Reference: 354 Schoolhouse Road – Sketch Plan Review 1
180 New Britain Blvd Associates, LLC, TMP #26-001-100 & 26-001-102

Pursuant to your request, Gilmore & Associates, Inc. has reviewed the Sketch Plan for the above-referenced project to identify any zoning, engineering, or planning issues that may have an impact on the proposed development.

2.	Date of Plan or Revision:	09-23-2022				
3.	Application for:	Subdivision & Land Development				
4.	Name of Subdivision or Land Development:	Galena Reserve Mobile Home Park

SHEET No. 4 OF 49

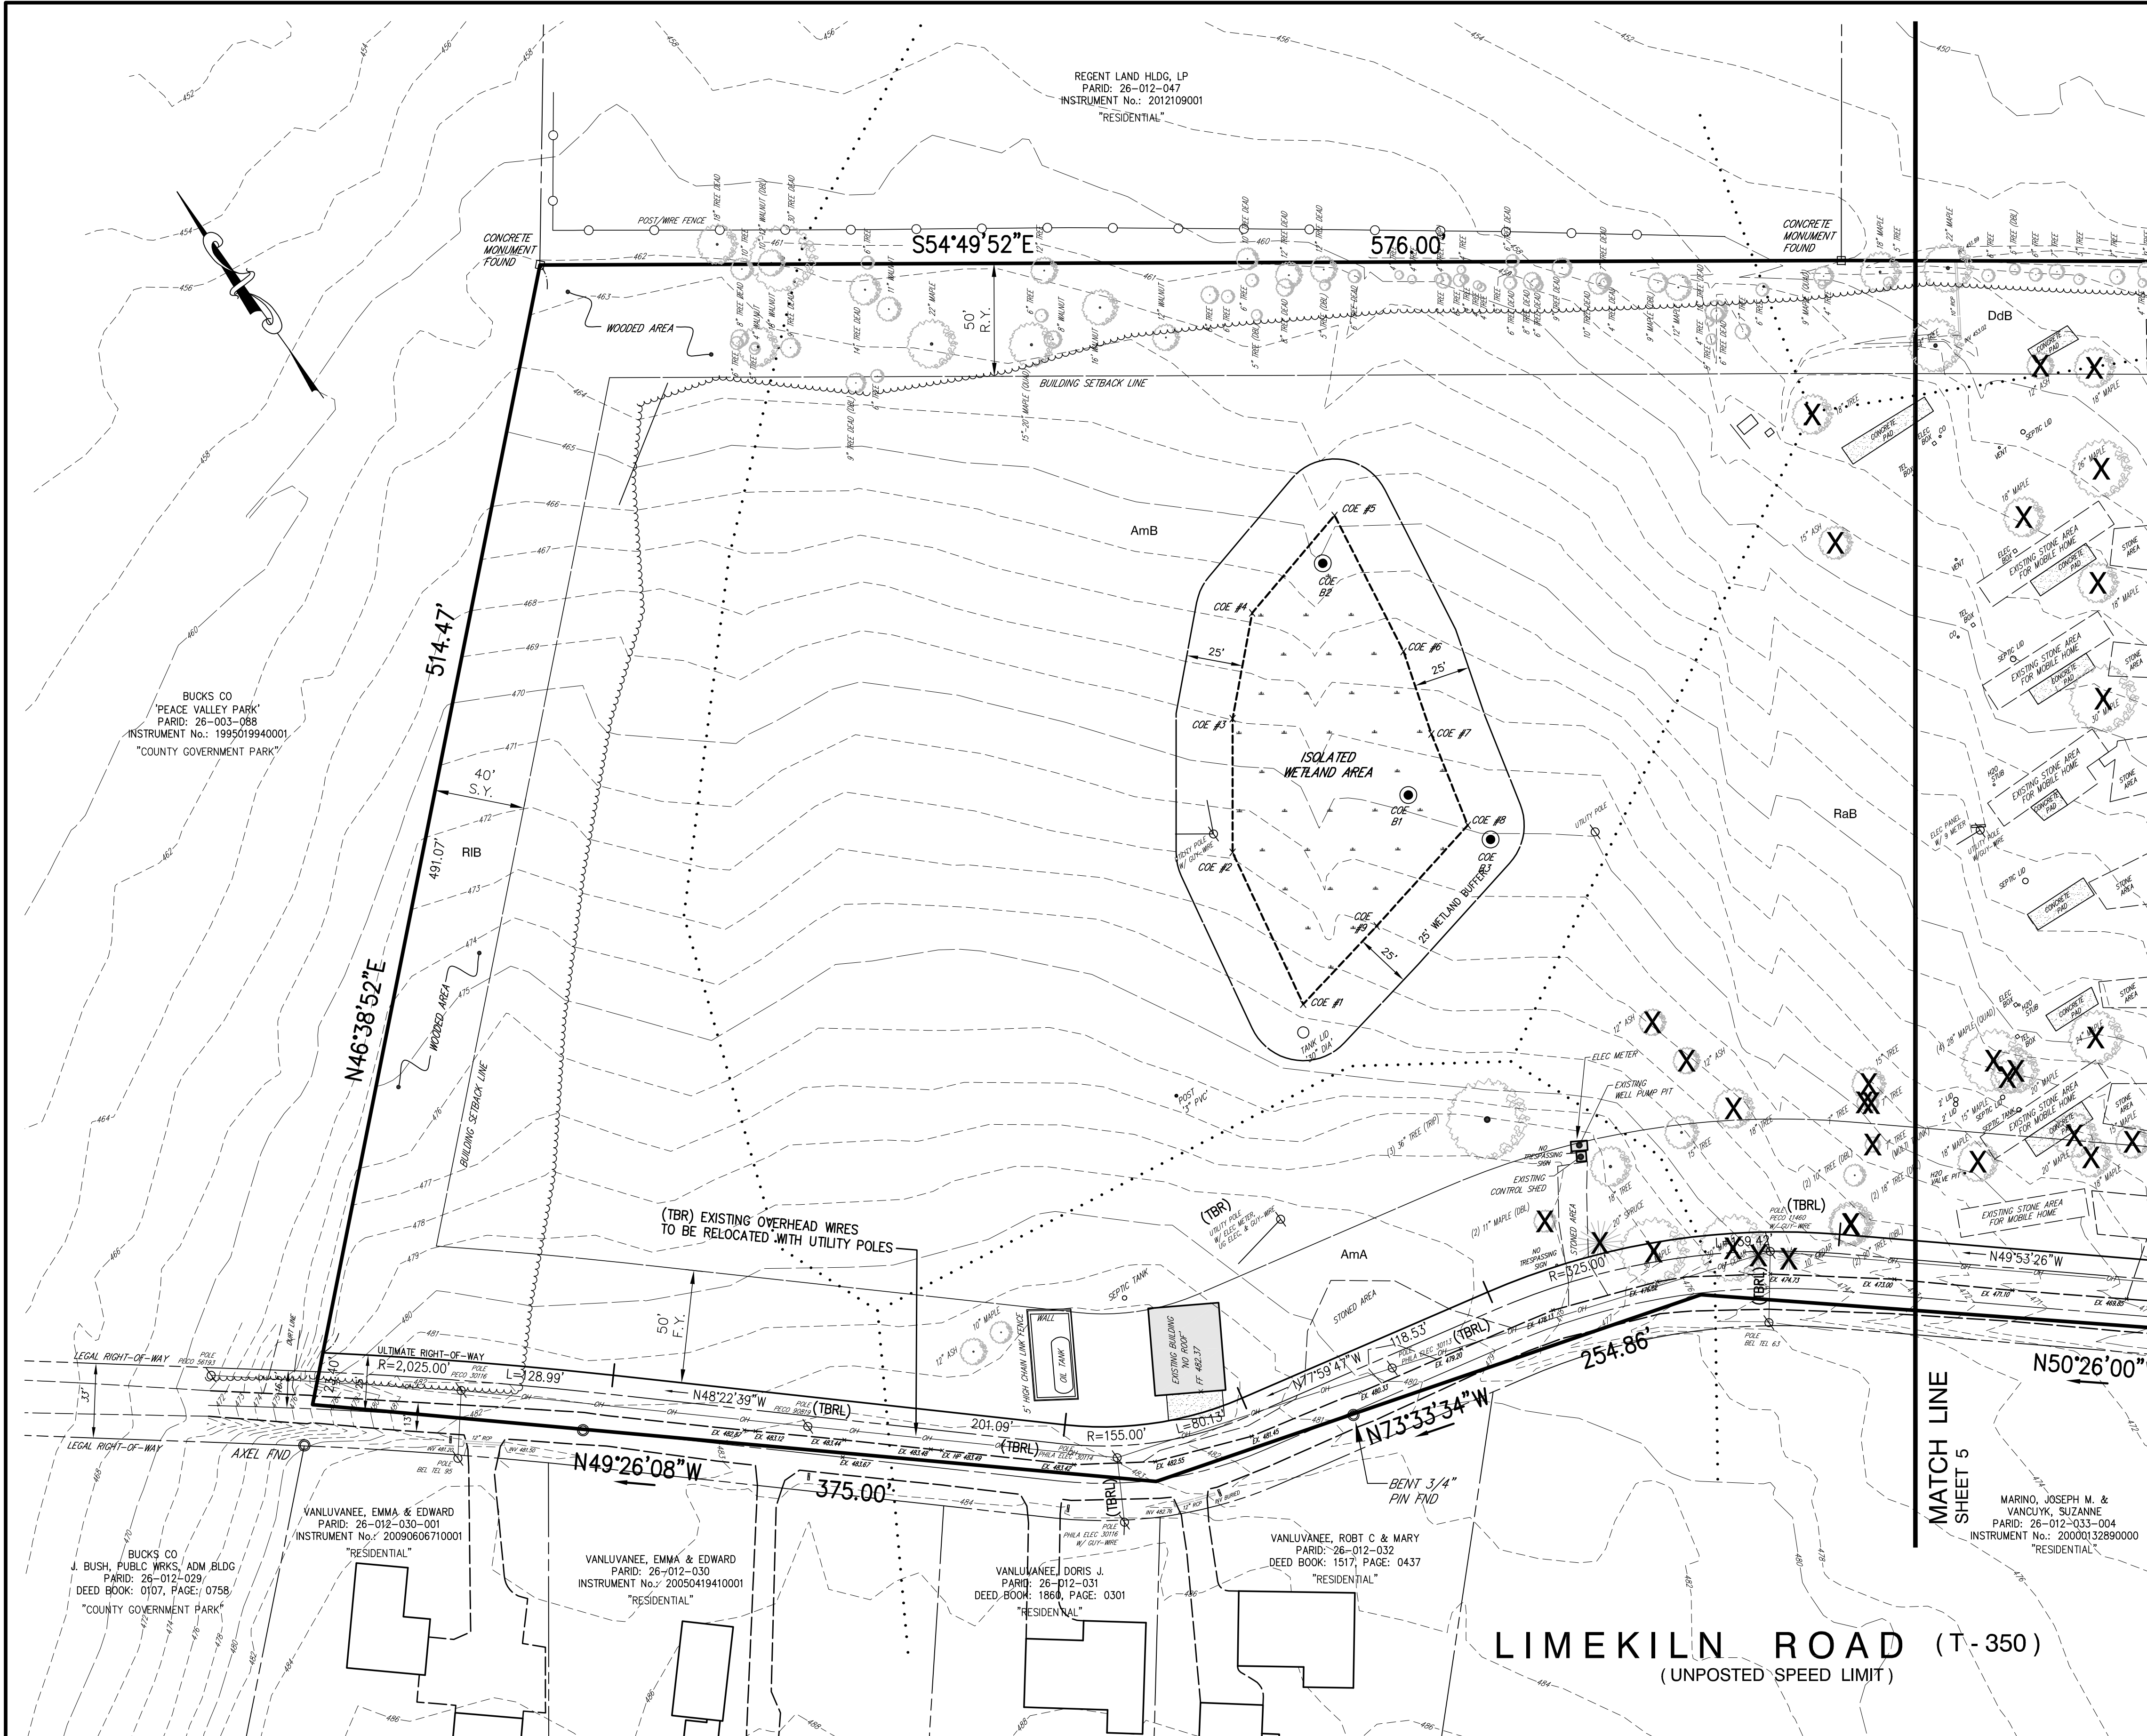
5. §22-502.D. – Existing features within the tract proposed for subdivision and/or land development and within 100 feet of the tract boundary shall be shown on the plans. We note that an aerial photograph plan has been provided on Sheet 4. We would support a waiver from this requirement conditioned upon the Applicant providing existing feature information for offsite water main and force main connections and any other information deemed necessary by the Township Engineer to facilitate the development such as buffers from offsite wetlands/watercourse. We note that Sheet 6 can be revised to be in a consistent format with Sheet 5 (aerial info is missing and limits of canopy are missing).

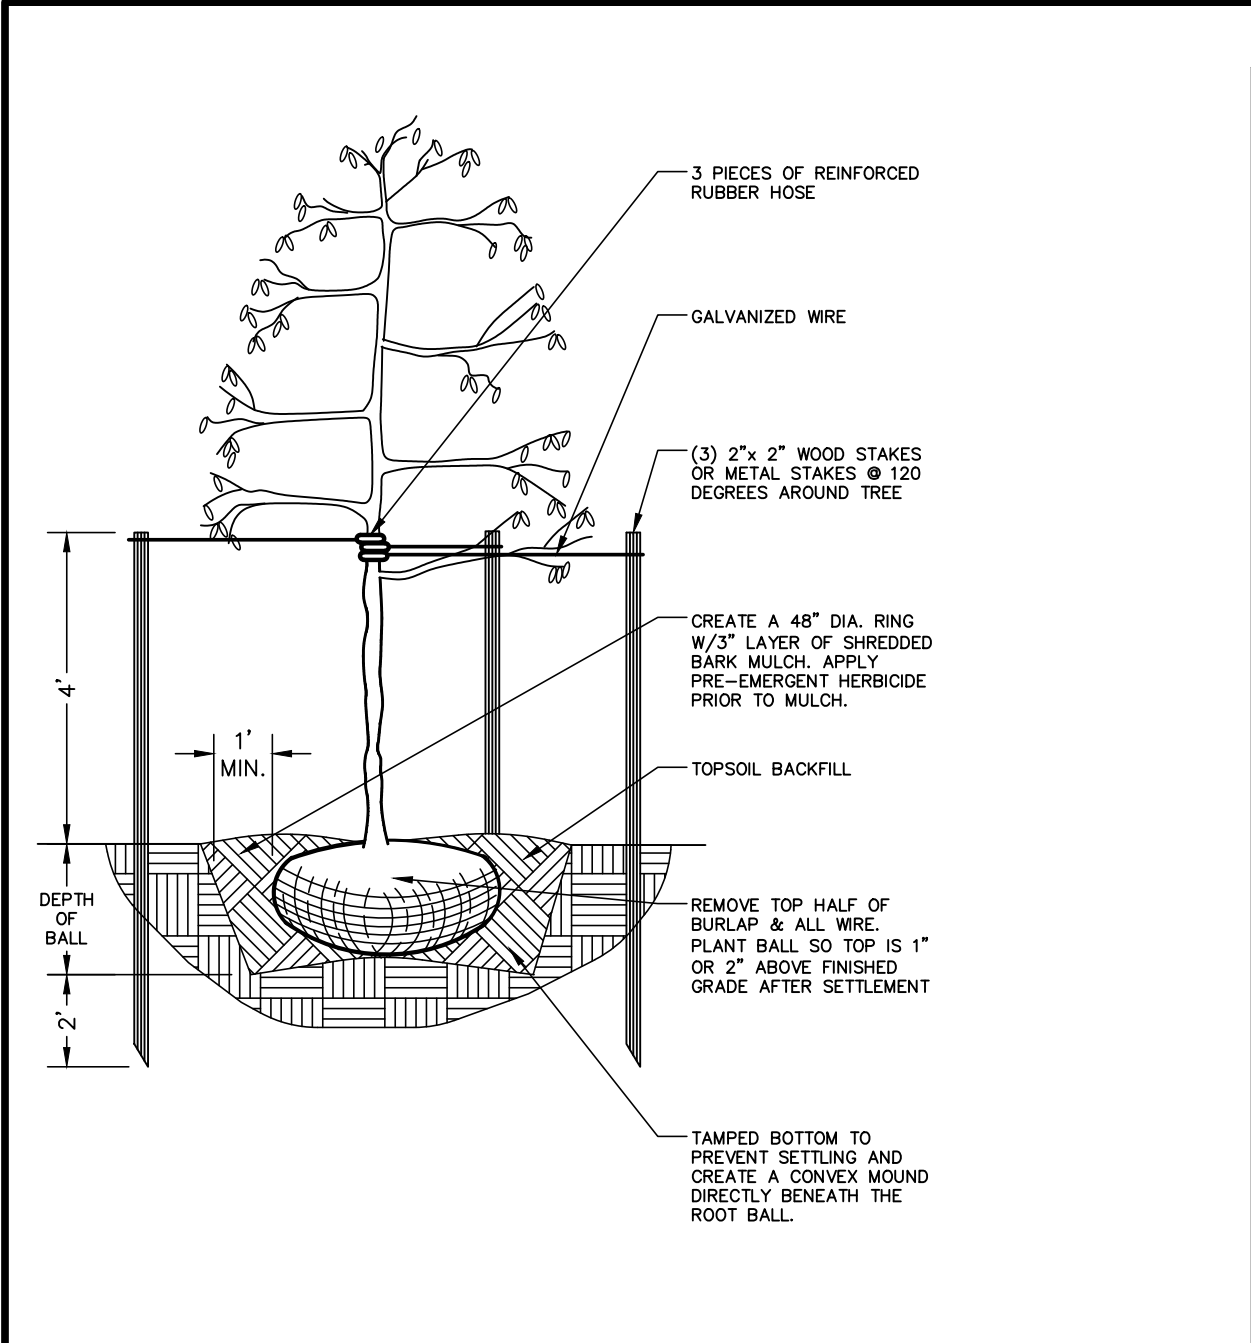
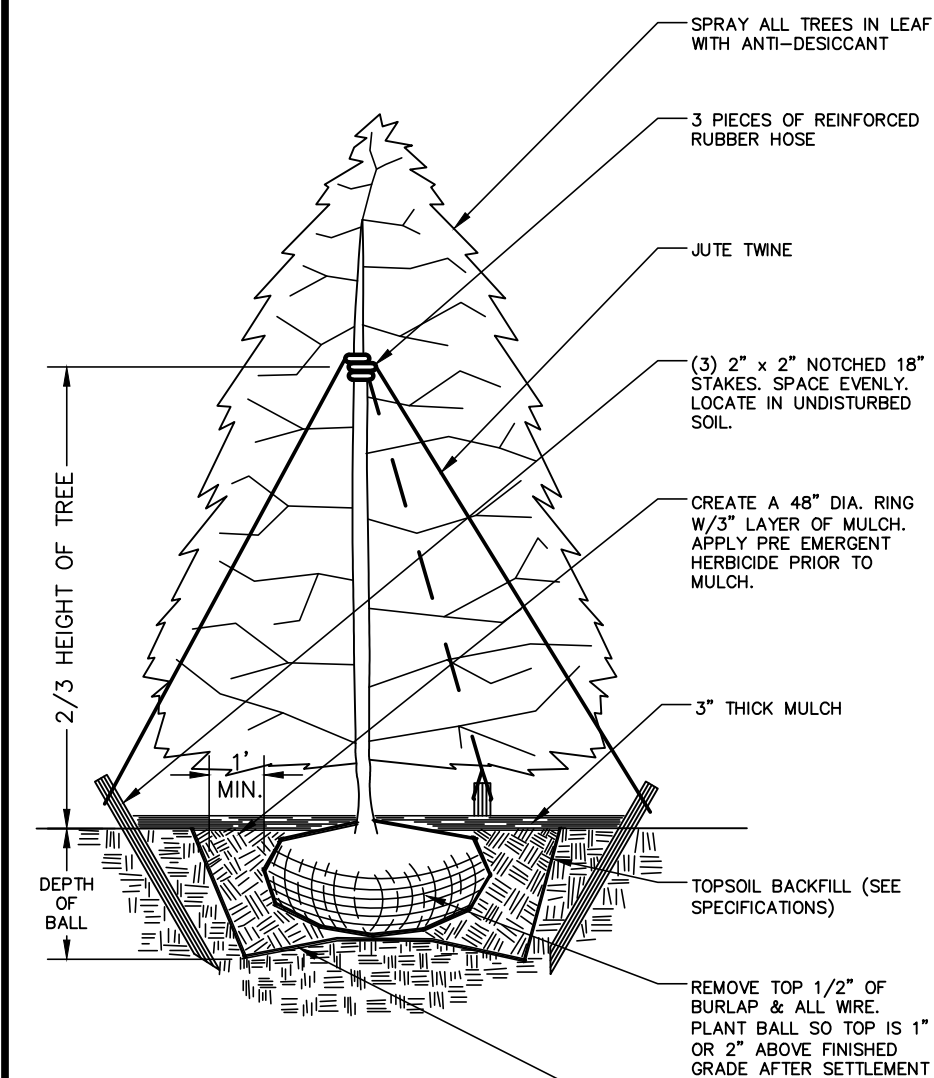
13. §27-2802.a.3.(h) – The Landscape Compliance Chart, Sheet 14, indicates the Applicant proposes to meet the buffer requirement with a berm varying in height from 3 to 5 feet and 1 flowering or evergreen tree per 20 feet and 1 shrub per 10 feet. However, eastern and northern buffers do not appear to include the required berm. The berm shall be provided, or an alternate buffer option specified.

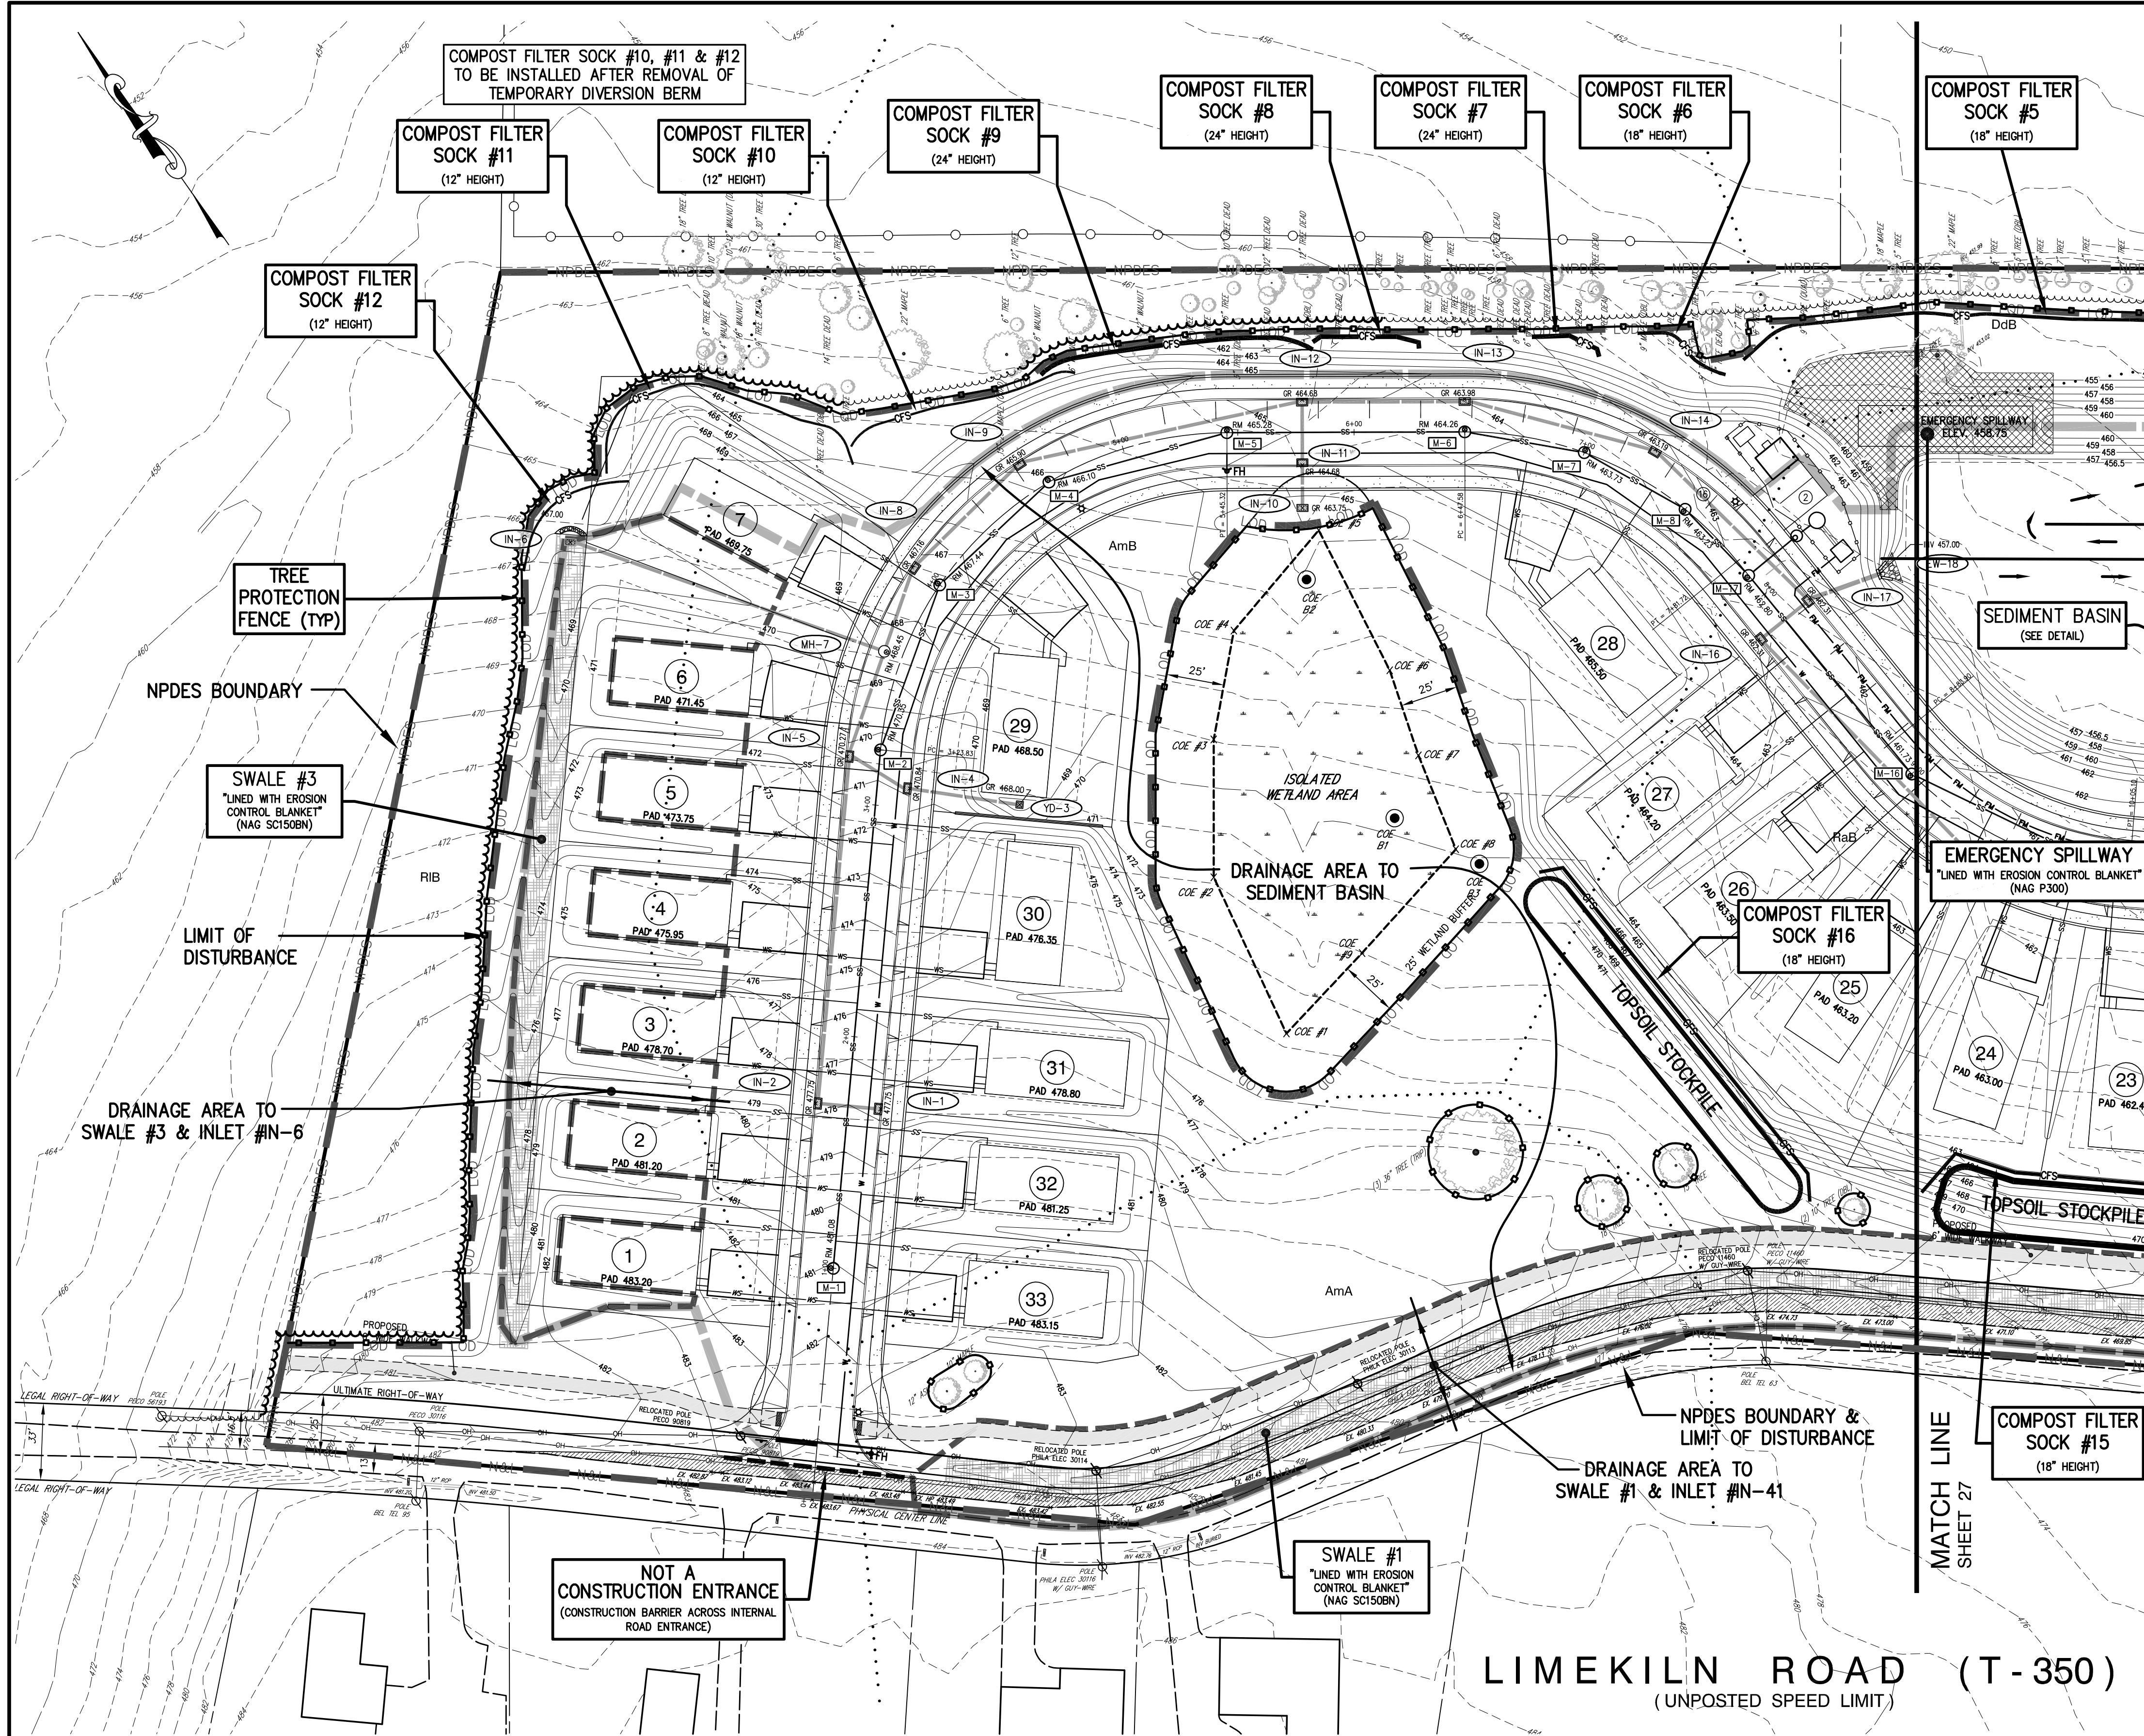
- b. Compost filter sock shall be provided around the isolated wetlands area until all upslope disturbance has been stabilized.
 - c. The proposed grading on the Erosion Control Plan (Sheet 27) indicates a sediment basin elevation of 456.50. This is not consistent with the sediment basin details on Sheet 32 which list a basin elevation of 456.00. The sediment basin bottom elevation shall be clarified.
